SUBJECT: ISSUANCE OF AMENDMENTS - McGUIRE NUCLEAR STATION, UNITS 1 AND 2  
(TAC NOS. M88120 AND M88121)

The amendments reduce the required minimum measured reactor coolant system flow from 385,000 gallons per minute (gpm) to 382,000 gpm.

SAFETY EVALUATION BY THE OFFICE OF NUCLEAR REACTOR REGULATION  
RELATED TO AMENDMENT NO. 141 TO FACILITY OPERATING LICENSE NPF-9  
AND AMENDMENT NO. 123 TO FACILITY OPERATING LICENSE NPF-17

MCGUIRE NUCLEAR STATION, UNITS 1 AND 2

Figure 2.1-1  
REACTOR CORE SAFETY LIMITS - FOUR LOOPS IN OPERATION

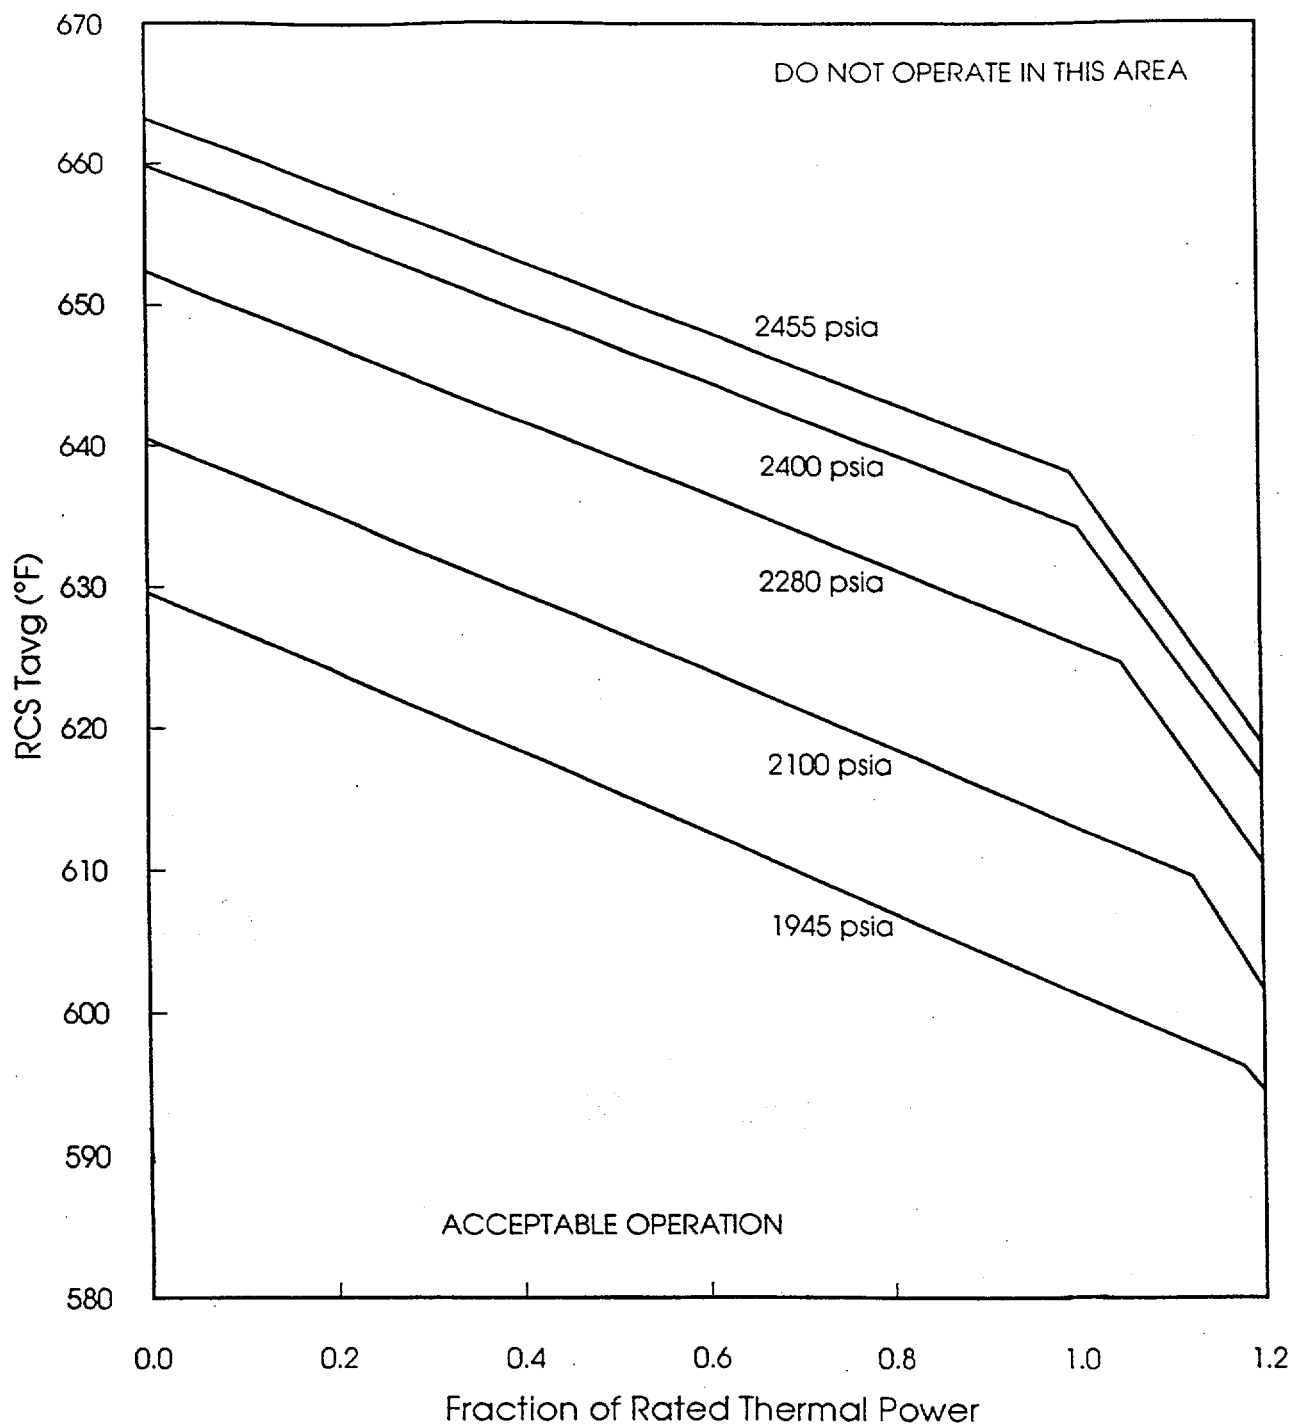
The reasons for the licensee's request in the October 25, 1993, application, as supplemented December 3, 1993, and February 14, 1994, are that the degrading of the steam generator tubes in McGuire, Units 1 and 2, have necessitated that tubes be plugged or sleeved, which reduces the available flow area in the steam generators and consequently reduces flow through the core. In addition, a hot leg temperature streaming phenomenon has affected the ability to accurately measure flow. As a result of these effects, it was difficult to ensure meeting the TS minimum flow requirements to maintain 100% power operation.

- 1) Figure 2.1-1, Reactor Core Protection Limits - Four Loops in Operation,

Figure 3.2-1 Reactor Coolant System Total Flow Rate Versus  
Rated Thermal Power - Four Loops in Operation

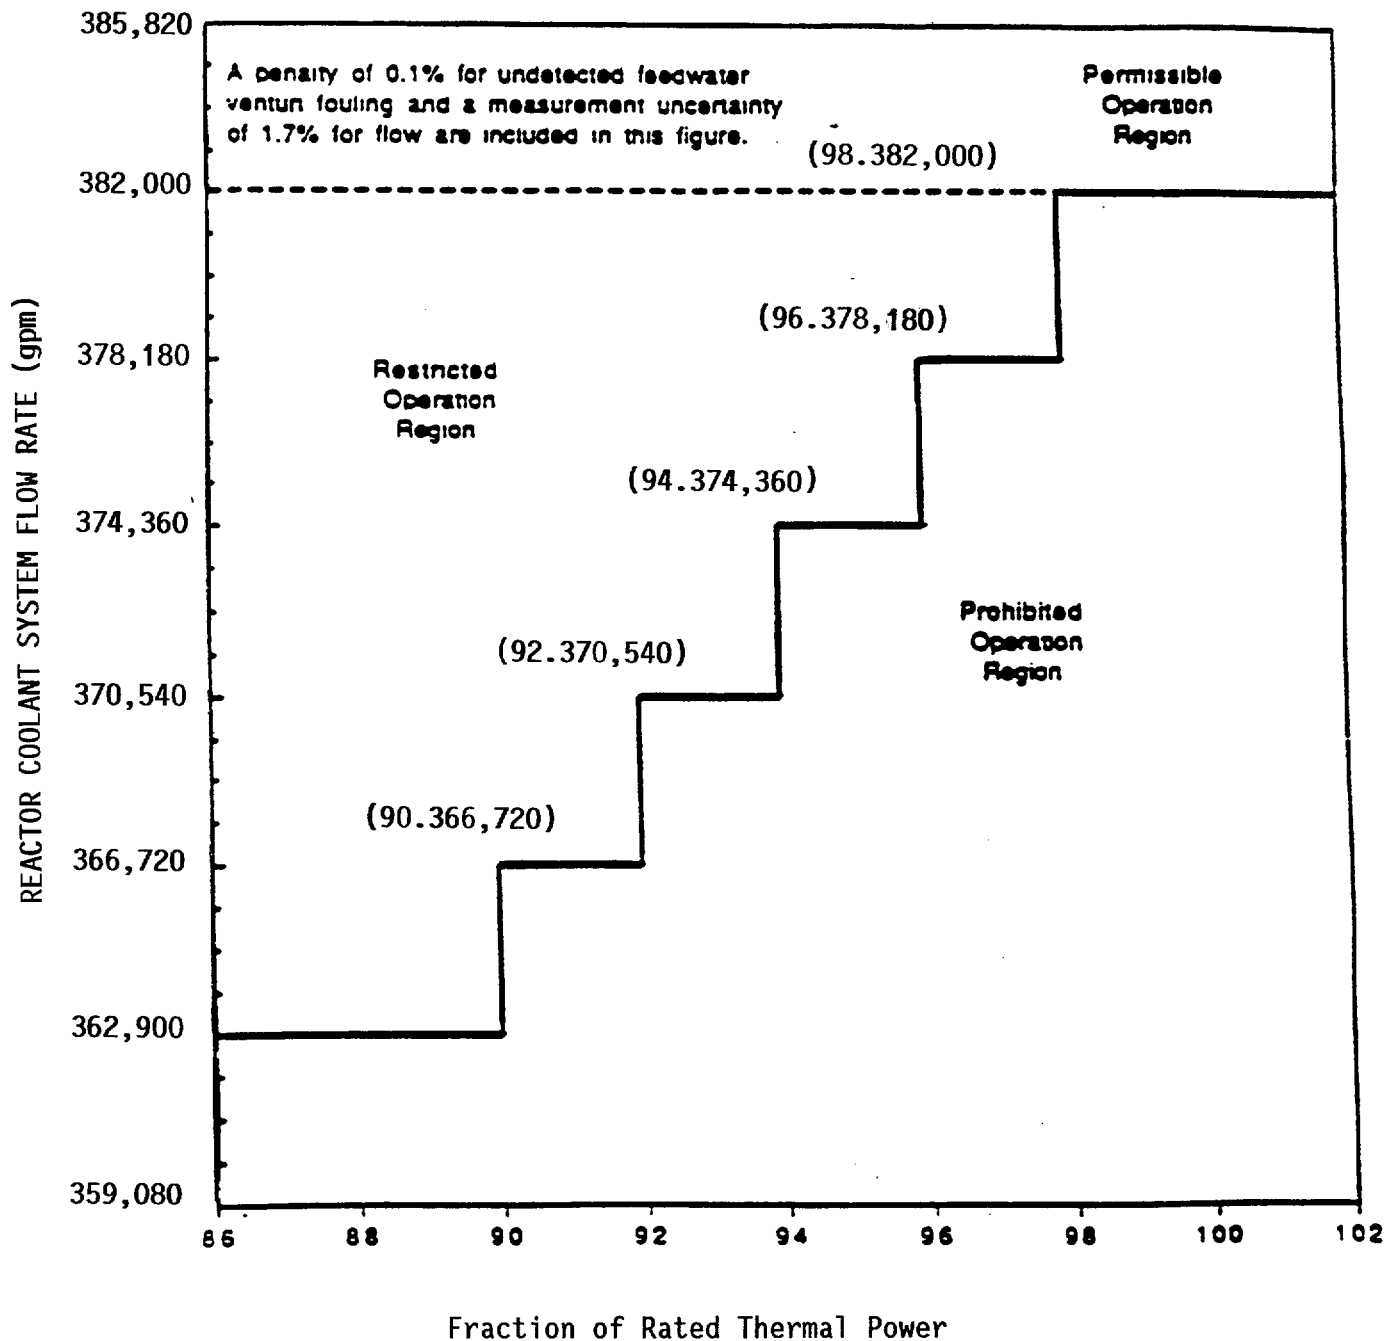
The thermal hydraulic design for the McGuire units was analyzed by the licensee with the reduction in RCS MMF to 382,000 gpm. The reduced flow rate resulted in a slight reduction of the margin in the core DNB limits. TS Figure 3.2-1, Reactor Coolant System Total Flow Rate Versus Rated Thermal Power - Four Loops in Operation, was revised to reflect the lower allowable

flow rate. For the changes made in RCS flow at reduced power, the licensee stated (Reference 2) that the RCS flow values were determined using the same 2% power per 1% flow reduction factor used in the existing TS figure. The axial Flux Difference Limits, TS Section 3.2.1, are unchanged and all the current thermal hydraulic design criteria are satisfied at the reduced flow conditions.
